# PLAN OF PROPOSED IMPROVEMENT

## ACACIA RIDGE PHASE 10

CITY PROJECT NO. 14833  
CONTRACT NO. 9340

Revision 2: 05/28/2024  
Sheet U-2: Changed pipe size P-1  
Sheet U-STM: Revised pipes P-1 and P-2,  
revised structures S-1 and S-2

UTILITIES PLAN & PROFILE - LONE OAK LANE  
ACACIA RIDGE PHASE 10  
M:\DESIGN\Projects\14833\CAD\Severs\14833SWR-PipeNetwork.dwg

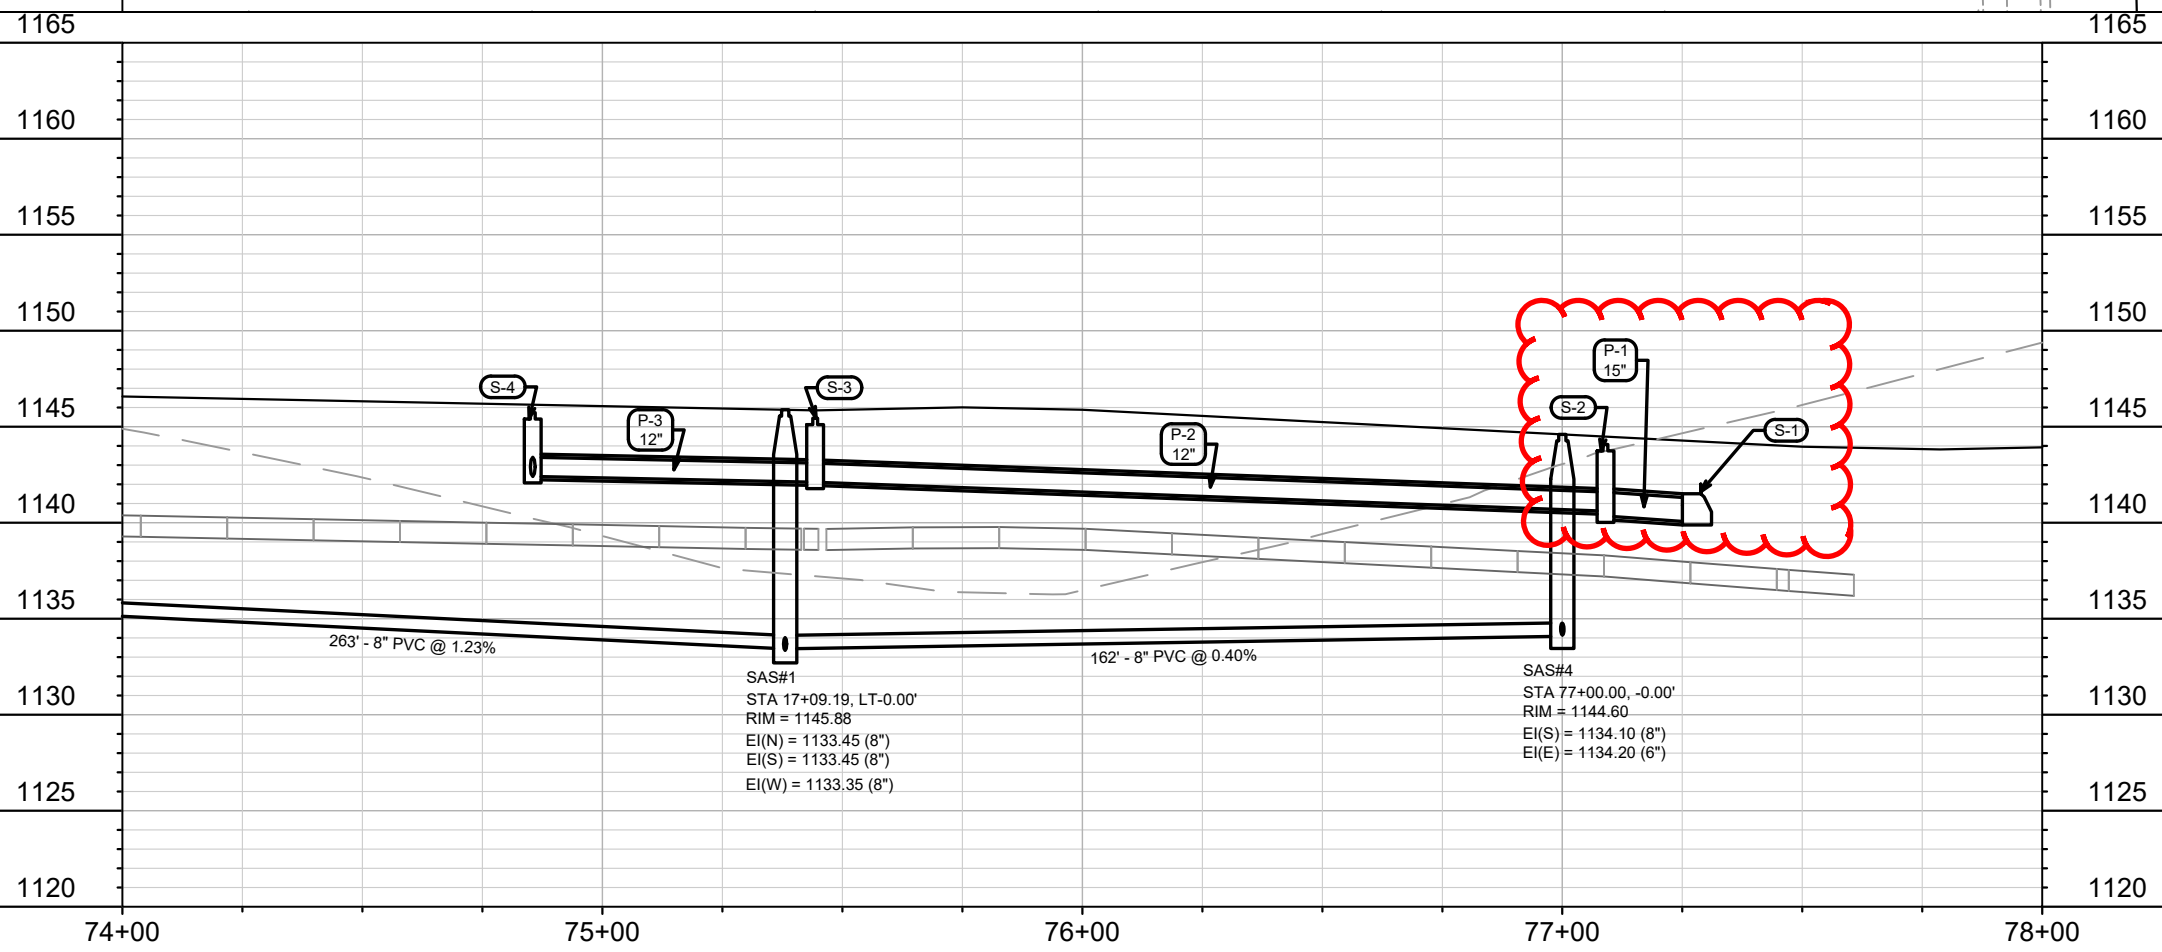
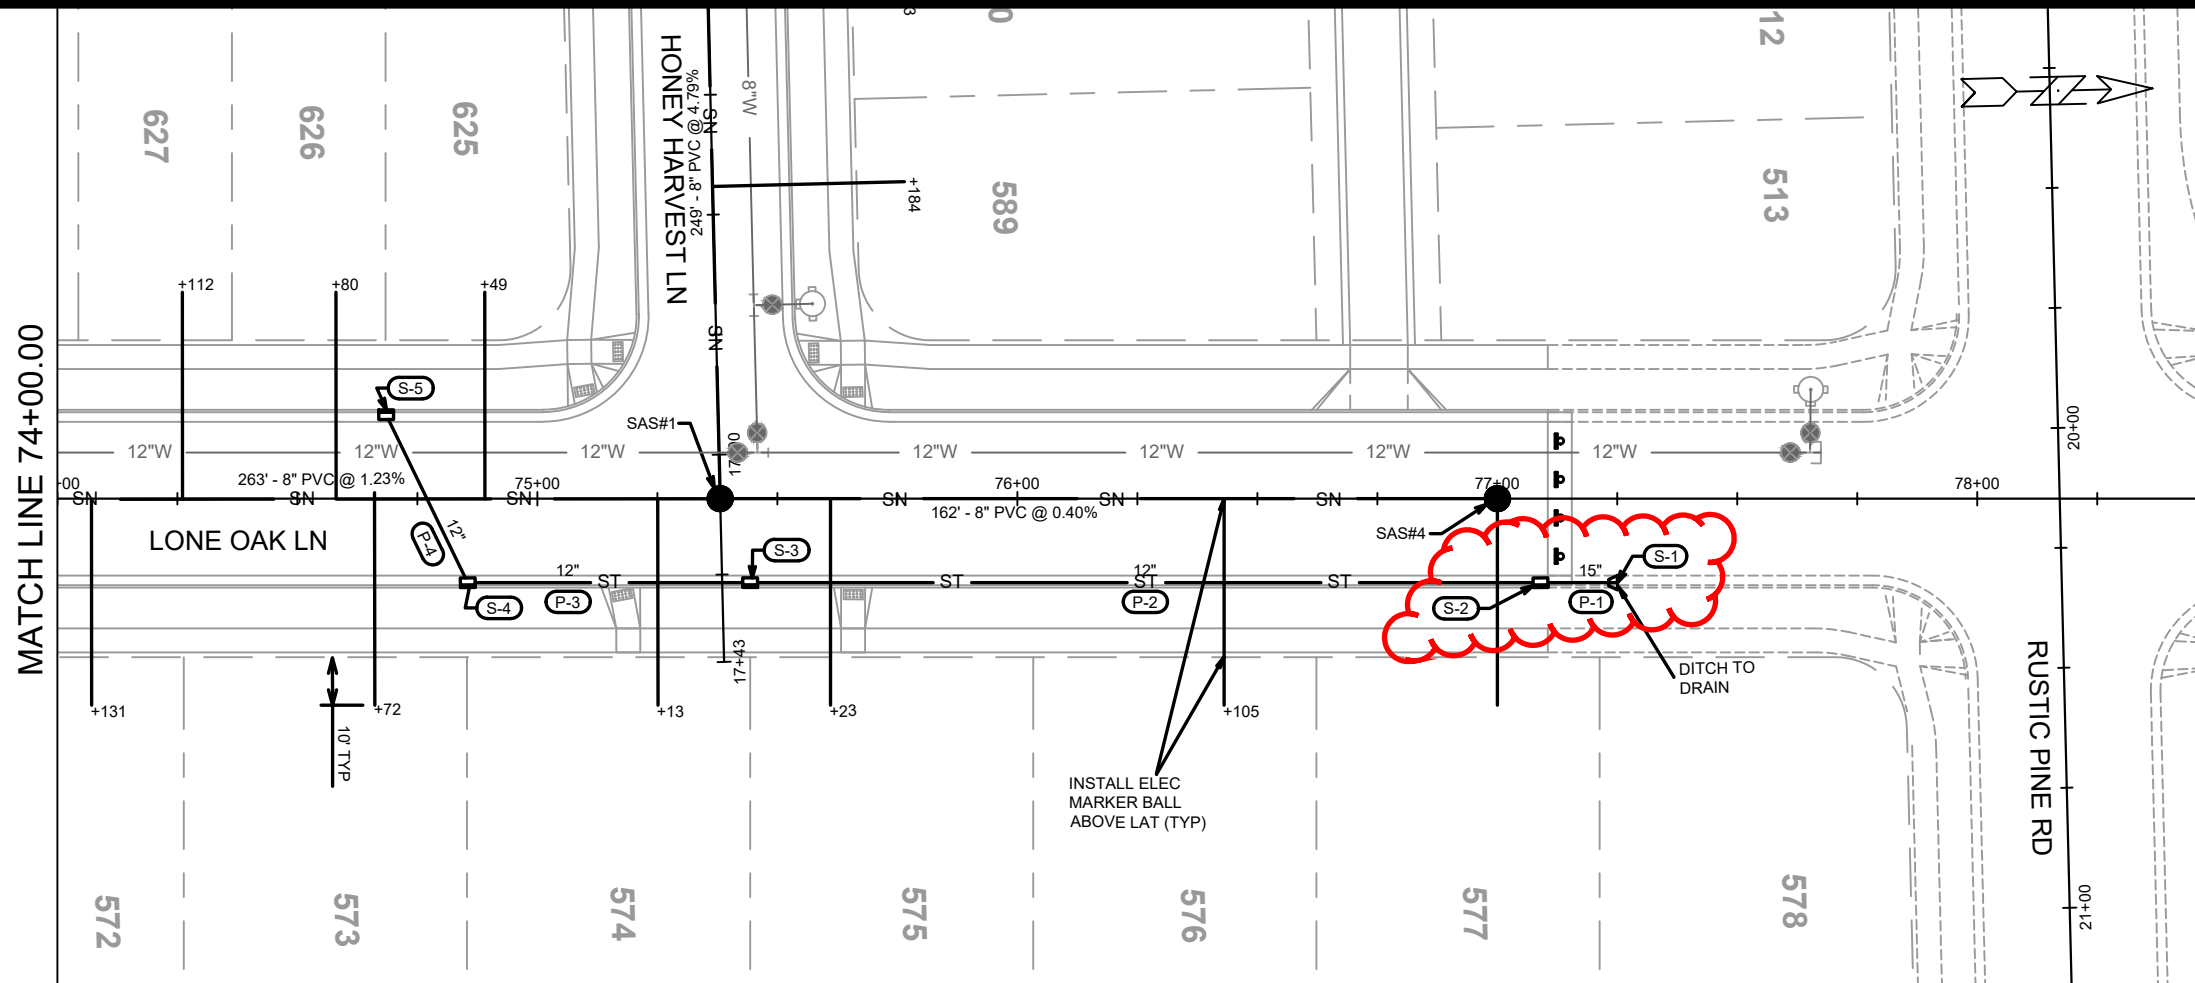
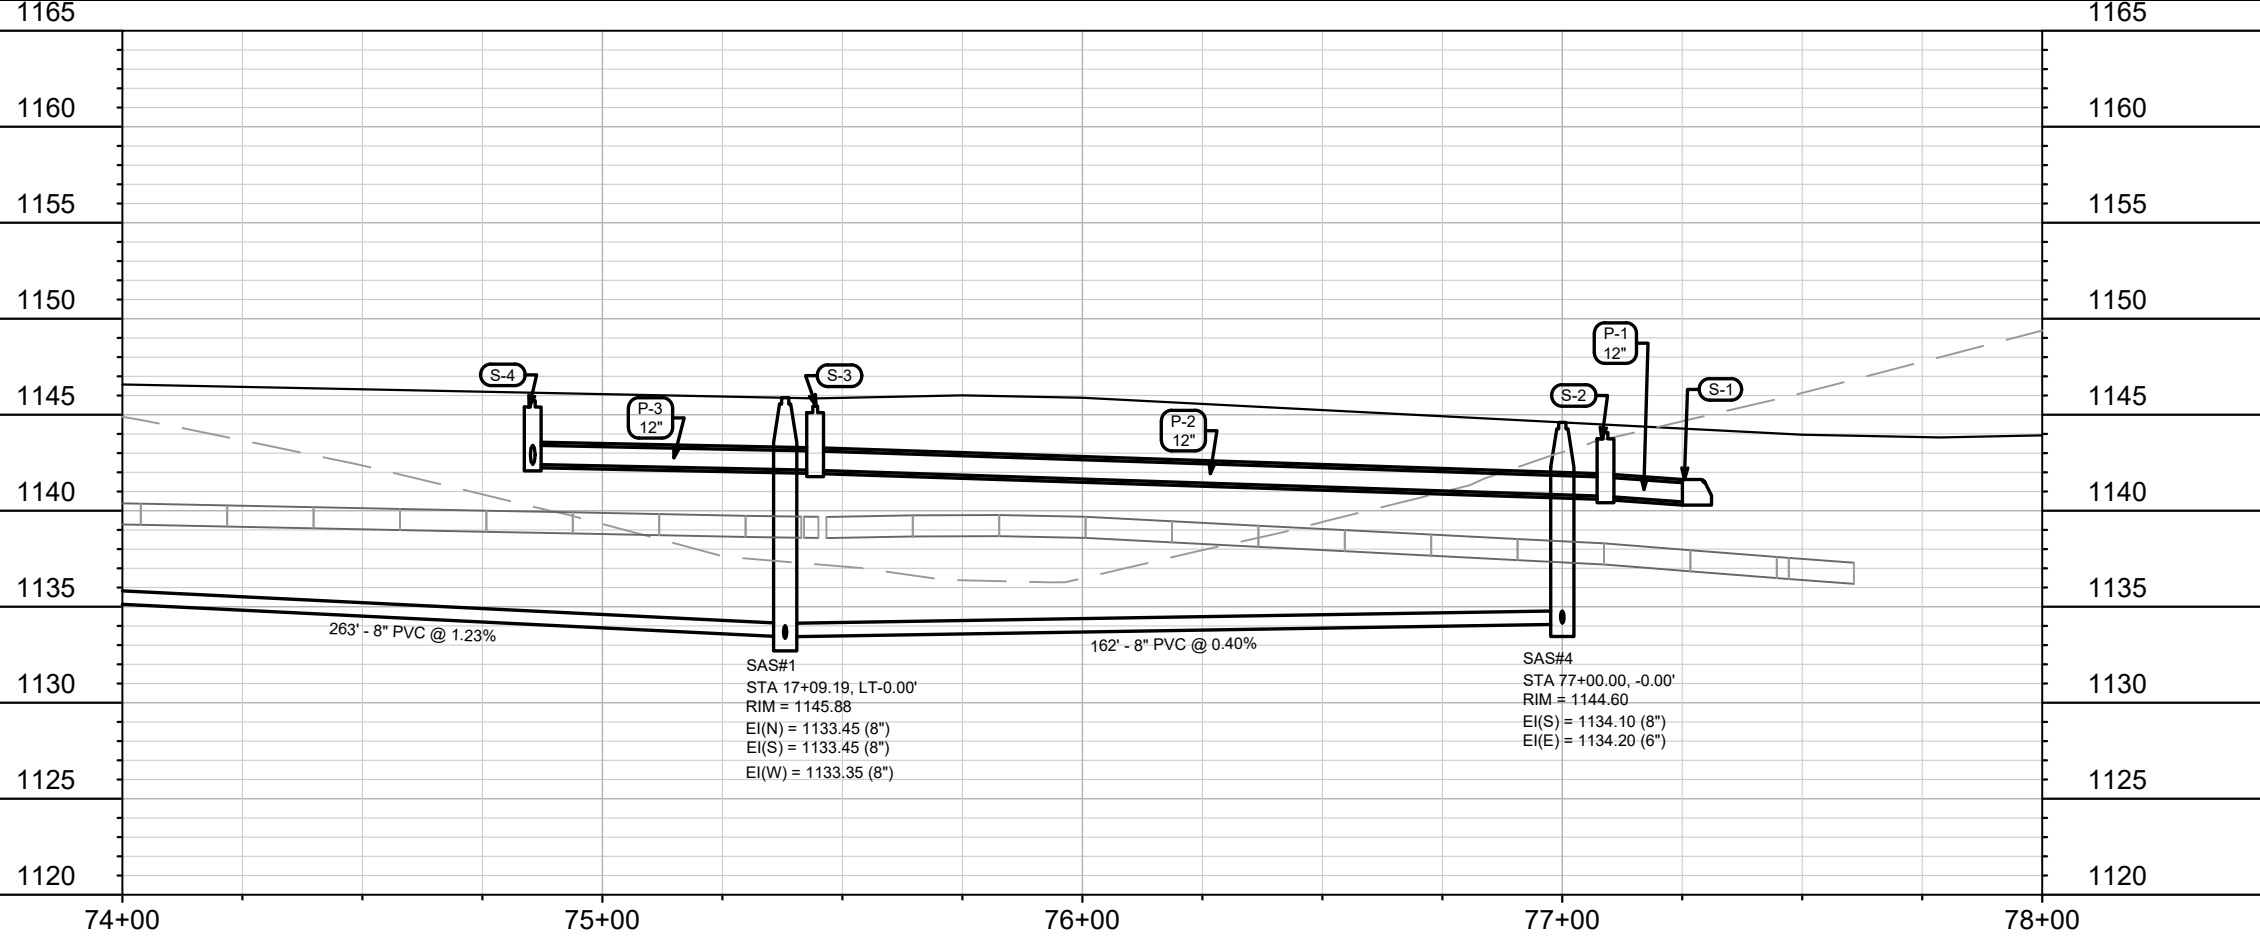
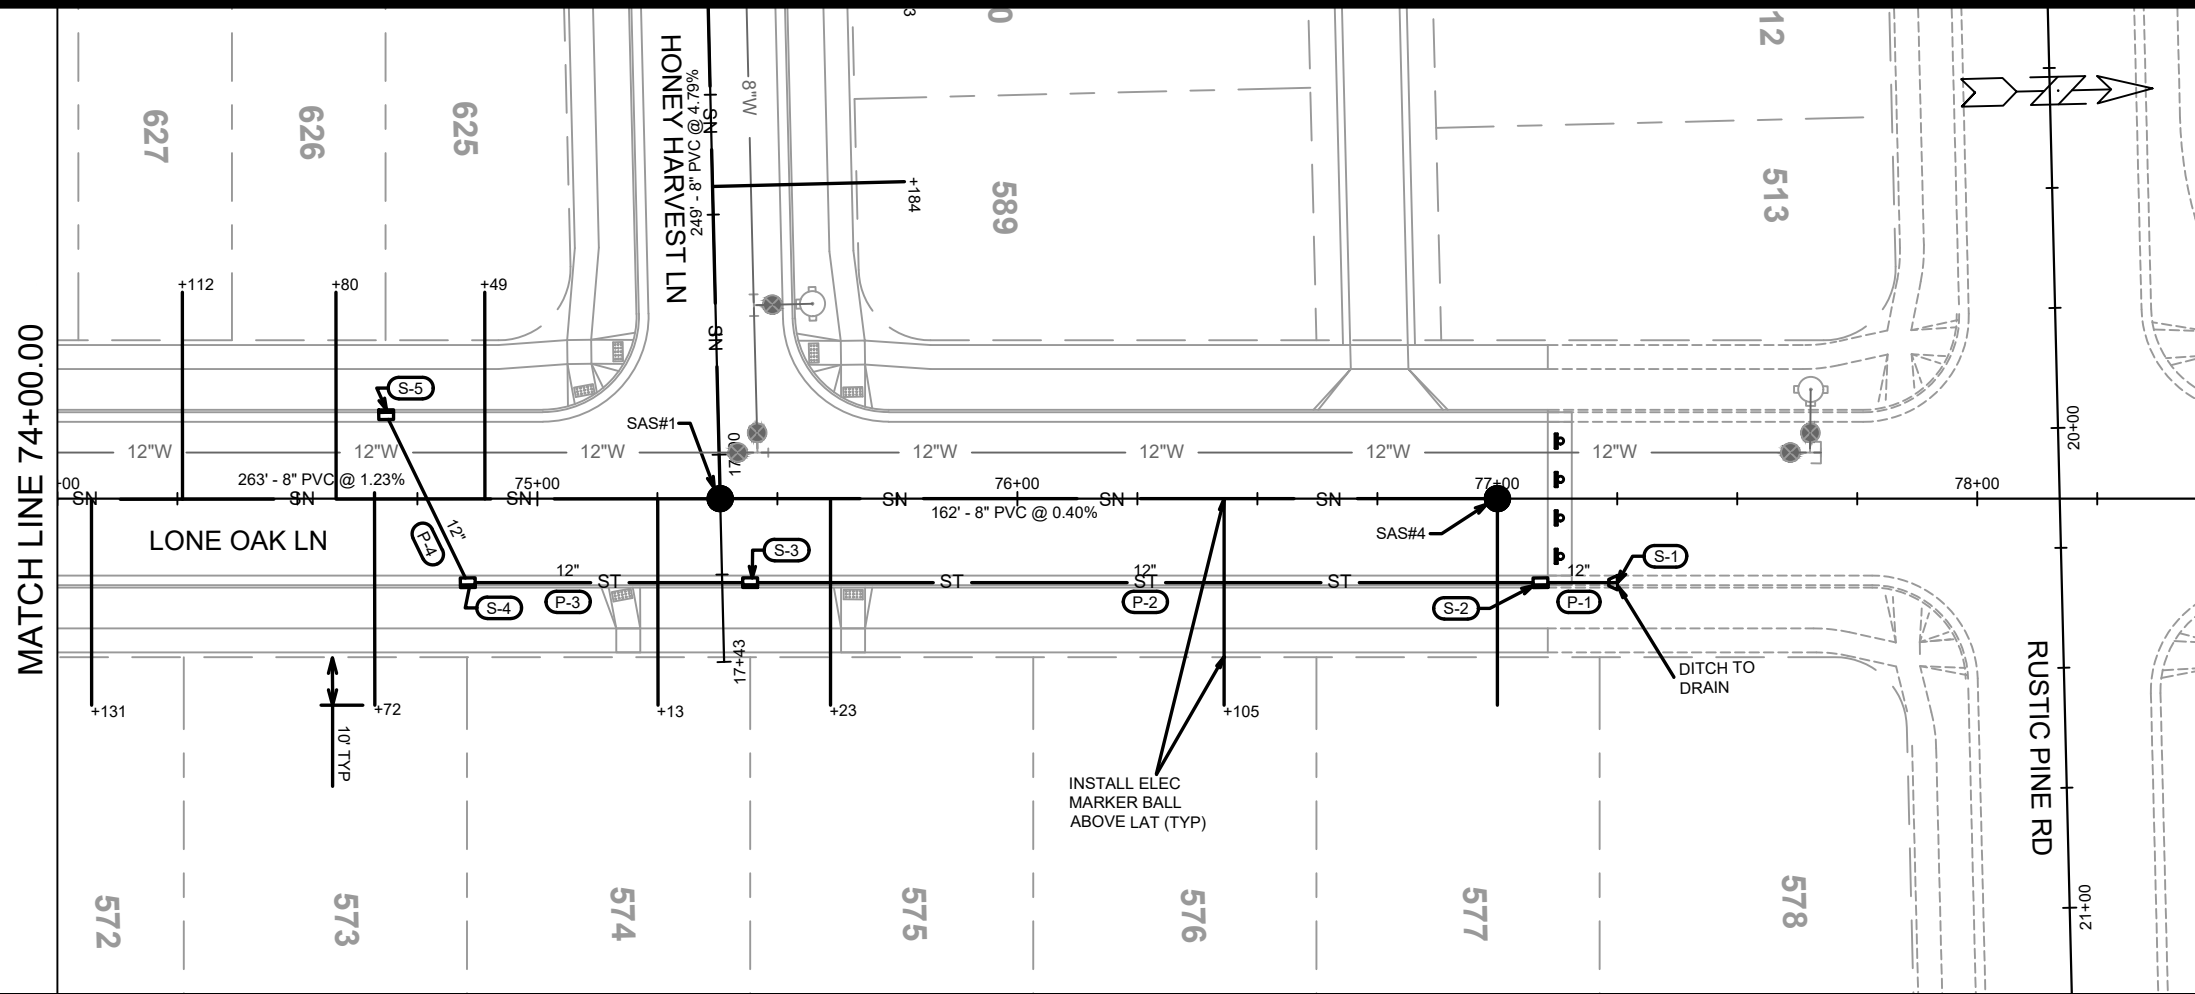
- Changed pipe size P-1
